Access Compliance Report

Public Rights-of-Way

(Curb Ramps)

Intersection ID: 13227	Main Street: SUNNYSIDE_AV	Cross Street: LAMAR_AV	Location: NW
ADA ID: 231860FAE5A9	Ramp Type: BlendTrans1	Initial Pass/Fail: Pass	Overall Compliance: No
		Severity Score: 2.5

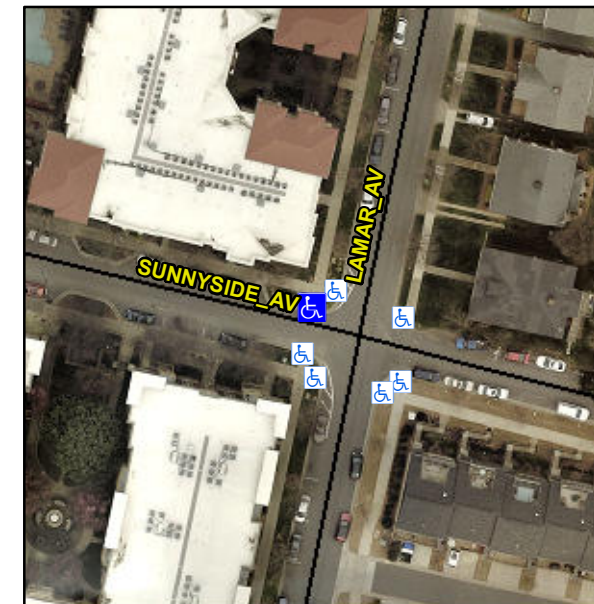
Not Found, R304.2.2-Perp, R304.3.2-Para, R304.5.3, R305.1.4

Compliance	Description	Data	Compliance	Description	Data
N/A	Ramp Length (in)	25.0	Yes	BlendTrans Slope (%)	1.0
Yes	Ramp Width (in)	71.0	Yes	BlendTrans XSlope (%)	1.4
N/A	Flare Type LT	None	N/A	Flare Type RT	None
N/A	Flare Slope LT (%)	N/A	N/A	Flare Slope RT (%)	N/A
N/A	Flare Traversable LT?	N/A	N/A	Flare Traversable RT?	N/A
Yes	Landing Length (in)	74.0	Yes	DWS Provided?	Yes
Yes	Landing Width (in)	72.0	Yes	DWS Contrast?	Yes
No	Landing Slope (%)	2.6	Yes	DWS Length (in)	24.5
No	Landing X Slope (%)	3.3	No	DWS Full Width?	No
N/A	Landing Curb? (Y/N)	No	Yes	DWS Offset (in)	0.0
N/A	Shared Landing?	Yes			
Yes	Gutter Ponding?	No	Yes	Gutter Slope (%)	0.1
Yes	Gutter Lip Ht (in)	0.2	Yes	Gutter X Slope (%)	1.1
N/A	Painted X Walk1?	No	N/A	Painted X Walk2?	N/A
	X Walk 1 Direction	To S		X Walk 2 Direction	N/A
	X Walk 1 Width (in)	N/A		X Walk 2 Width (in)	N/A
	X Walk 1 Slope (%)	6.2		X Walk 2 Slope (%)	N/A
	X Walk 1 X Slope (%)	2.2		X Walk 2 X Slope (%)	N/A

N/A	Ramp inside XWalk1?	N/A	N/A	Ramp inside XWalk2?	N/A
	Road Slope (%)	2.2		Clear Space?	Yes
	Road X Slope (%)	6.2	N/A	Clear Space to XWalk (in)	N/A
Yes	Any Obstructions?	No	Yes	Storm Grate/Utility Hazard?	No
	Obstruction Type			Storm Grate/Utility Type	
		N/A			N/A
			Yes	Surface Condition? (G/P)	Good
			No	Curb Slope (%)	14.3

Remove & Replace Curb Ramp With Two New Directional Ramps or Equivalent.
